UNITED STATES PATENT AND TRADEMARK OFFICE

APPLICATION NO.	FILING DATE	FIRST NAMED INVENTOR	ATTORNEY DOCKET NO.	CONFIRMATION NO.
10/695,158	10/29/2003	Sy Wiley	025651-00002	7125

Office Action Summary

DETAILED ACTION

Fig. 1
Related Art

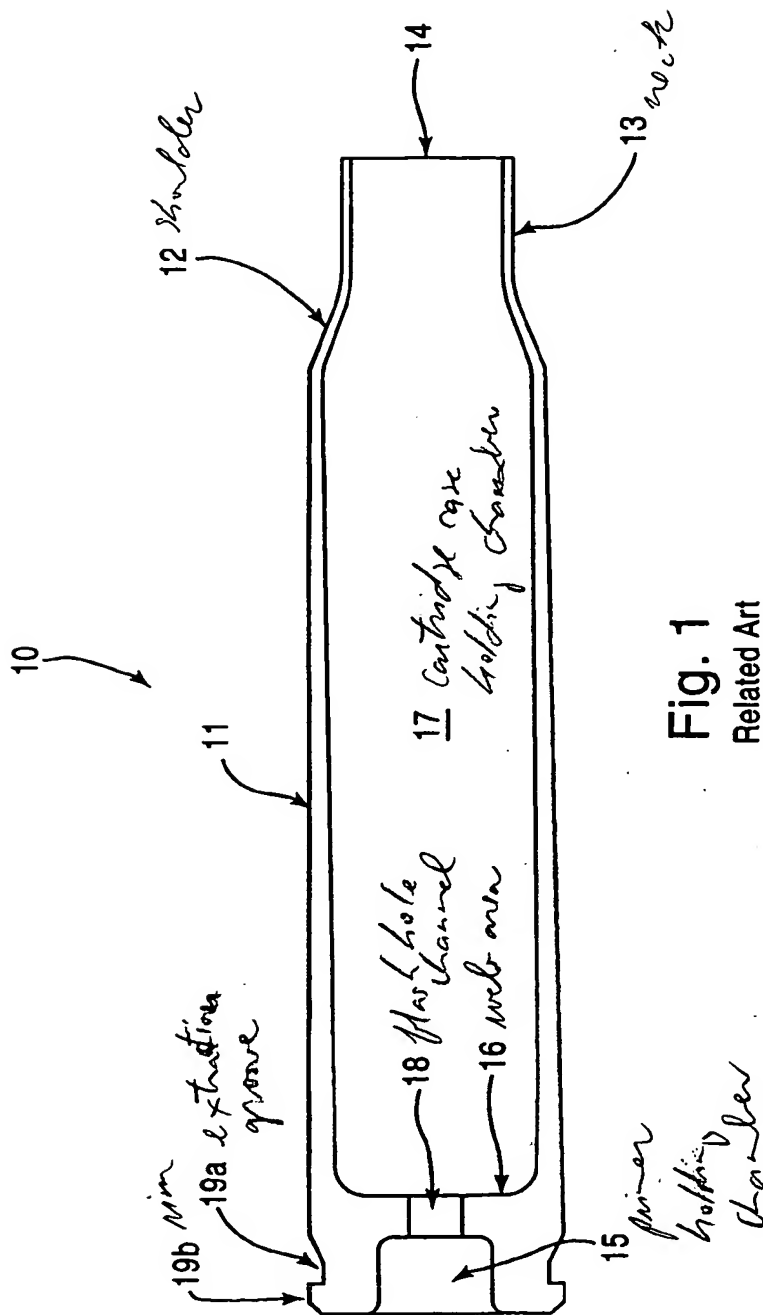
5. Claims 8-16 are rejected under 35 U.S.C. 103(a) as being unpatentable over Applicant's Admitted Prior Art (as set forth in Figures 1, 2, 3A, 3B, 4, 5, and paragraphs [0003] to [0028] in the specification; hereinafter is referred to as AAPA) in view of West et al. (US 5,616,642) (please see Figures 1, 2, 3A, and

3B of AAPA attached at the end of this Office Action for further explanation regarding to claims 8-15).

AAPA discloses a lead-free cartridge case capable of holding a bullet having a cannellure formed along an outer circumferential surface of a body of the bullet, the cartridge case comprising:

- a cylindrical body having a front end and a rear end opposite the front end;
- a mouth defined by the front end of the body;

- engaging means for engaging the bullet, the engaging means being disposed along a perimeter of the mouth;

- a groove formed along an outer circumferential surface of the body in a vicinity of the rear end of the body;

- a web extending radially inward relative to the body and disposed intermediate the groove and the mouth, wherein the web separates a bullet holding chamber located on a front end side of the web from a primer holding chamber located on a rear end side of the web; and

- walls of the body which define the bullet holding chamber and are bendable in a direction toward and away from a longitudinal axis of the body, wherein the engaging means are configured to snap fit the cannellure of the bullet.

Fig. 2
Related Art

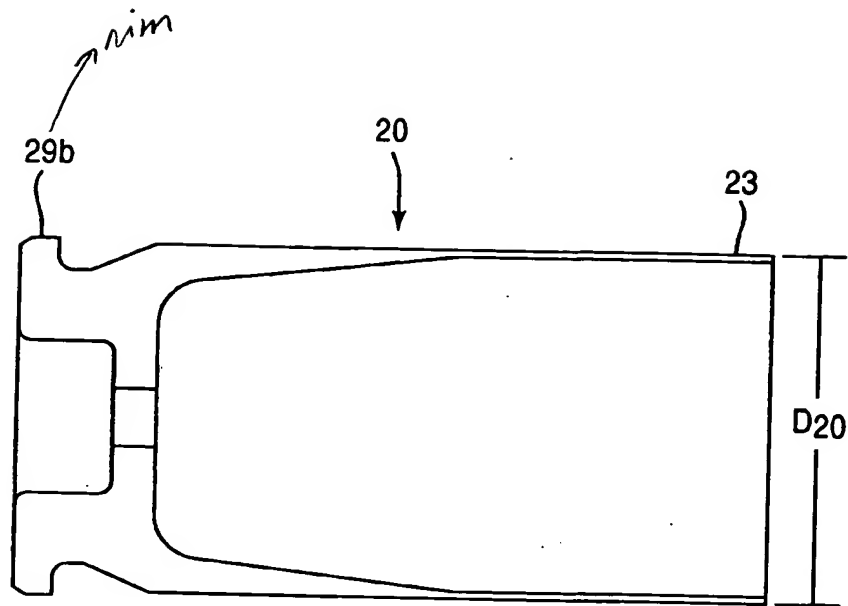
For claim 9, AAPA further discloses the walls defining the bullet holding chamber include tapered walls arranged oblique relative to the longitudinal axis of the body and straight walls arranged parallel relative to the longitudinal axis of the body, wherein the tapered walls taper away from the longitudinal axis of the body in a direction from the rear end to the front end of the body and transition to the straight walls at a blend point.

For claim 10, AAPA further discloses the engaging means include a lip lock having either one of an asymmetrical configuration or a symmetrical configuration.

For claim 11, AAPA further discloses the lip lock includes a base portion parallel relative to the longitudinal axis of the body and coinciding with the outer surface of the body, a tapered portion arranged oblique relative to the

longitudinal axis of the body, and an engaging portion, wherein the engaging portion is configured to fit within the cannellure of the bullet.
